Revised Independent Assessment of Re-revised Basement Excavation Justification for Planning Application 2014/7908/P

Site	140-146 Camden Street London NW1 9PF
Client	London Borough of Camden
Date	July 2015
Our Ref	BIAREV/5528

Figure 1: Extract from the Environment Agency's map of 'Risk of Flooding from Surface Water'.
 Ordnance Survey © Crown copyright 2014. All rights reserved. Licence No.100051531.

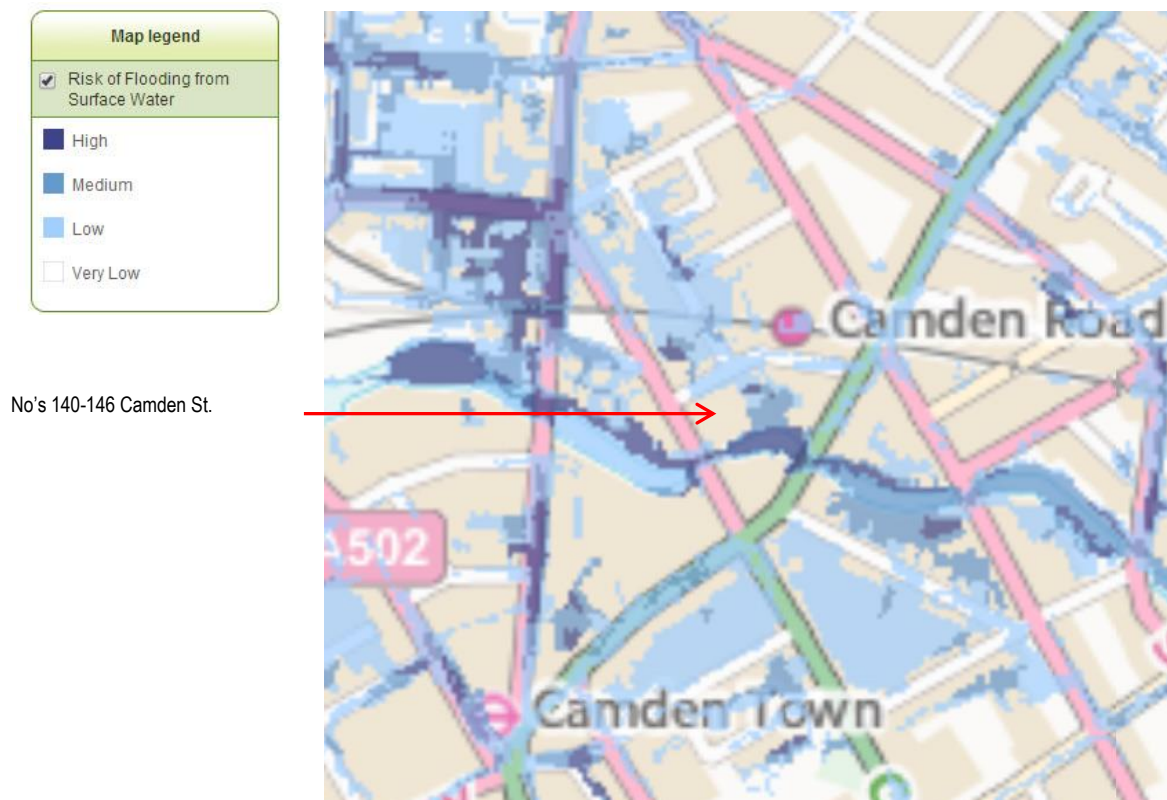
- 2.3.21 An extract from the EA's map of 'Risk of Flooding from Surface Water' (EA website, 2014) is presented in Figure 1 below, which shows that a 'High' risk of surface water flooding from the adjacent canal is predicted, including the towpath alongside the site of current interest. Appropriate flood resistance measures have now been recommended in the Flood Risk Assessment.
- 2.3.22 It is understood that the published Environment Agency map of surface water flood risk is less detailed than the full model, so the EA could be consulted for further details of the maximum predicted flood level of water from the canal.
